Measured vs. Simulated Correlation of Package Model

For IEEE 802.3ck

- During D1p4 comment stage, [comments #115](#), [#116](#), and [#117](#) proposed the following change
 - $C_p = 87 \text{ fF} \rightarrow 60 \text{ fF}$
- One contribution, [bois 3ck adhoc 01 011321](#), shared related justifications
- Remind #1: there were some previous contributions on this topic & we set up the consensus of $C_p = 87 \text{ fF}$ based on them
 - [mellitz 3ck adhoc 03 081518](#), [benartsi 3ck 01 0119](#), [benartsi 3ck 01a 0319](#), and others
- Remind #2: COM is sensitive to C_p value, [wu 3ck 01 0119](#)
 - COM difference $\sim 0.3 \text{ dB}$ for $C_p = 87 \rightarrow 60 \text{ fF}$
- The correlation of measured and simulated package models was analyzed
 - $C_p = 87 \text{ fF}$ is more correlated to measured TDR than 60 fF

Information of IEEE COM PKG Model & BGA Ball

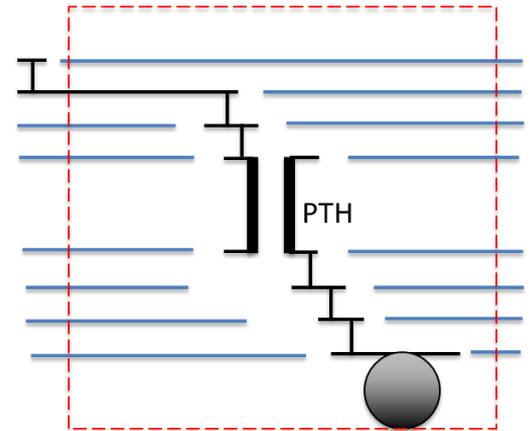
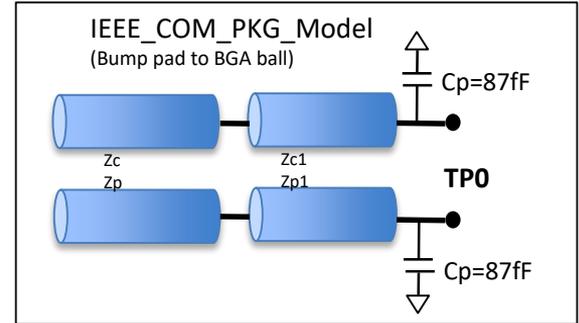
- IEEE PKG Model
 - Z_c, Z_p : set to align PKG substrate design
 - $Z_c = 92.5 \text{ Ohm}, Z_p = 6 \text{ mm}$
 - Z_{c1}, Z_{p1}, C_p : adopt IEEE values
 - For Via, PTH, & BGA ball
 - $Z_{c1} = 92.5 \text{ Ohm}, Z_{p1} = 1.8 \text{ mm}$
- Observations of IEEE_COM_PKG_Model
 - Two cascaded TL with C_p can approximate the EM simulation results well
 - C_p : model not only BGA ball, but also the interconnection between via and ball
 - Extracting BGA ball only with the EM simulator cannot represent the C_p and thus under-estimate capacitance value
- BGA geometry
 - BGA diameter = 600 μm
 - Ball pitch = 1000 μm

TDR Response for measurement, EM model and IEEE_COM_model

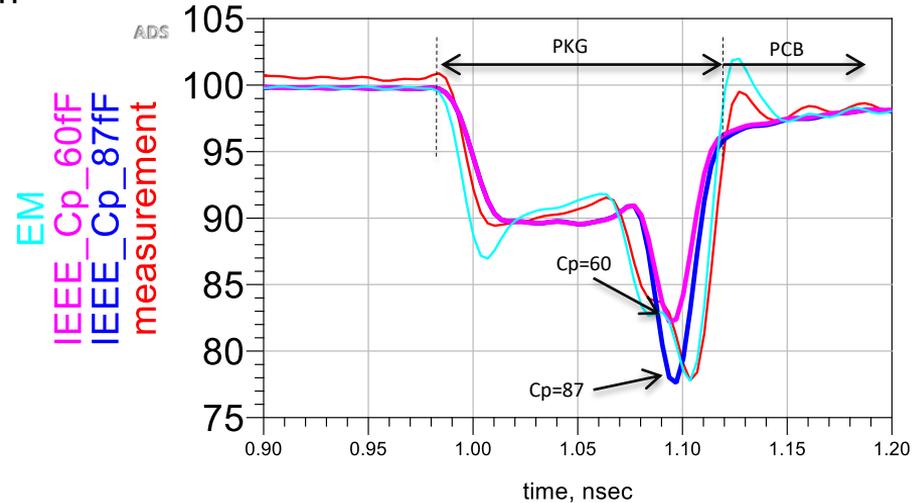
- EM model matches well with measured TDR data
- 'COM_Cp_87fF' model matches well at PKG part
 - $Z \approx 78 \text{ Ohm}$ @ BGA ball, close to measured data
 - $Z \approx 82 \text{ Ohm}$ for $C_p = 60 \text{ fF}$

- Based on the previous analysis & this new correlation data, we suggest
 - Keep $C_p = 87$ fF in IEEE COM PKG model for considering big packages in the host side
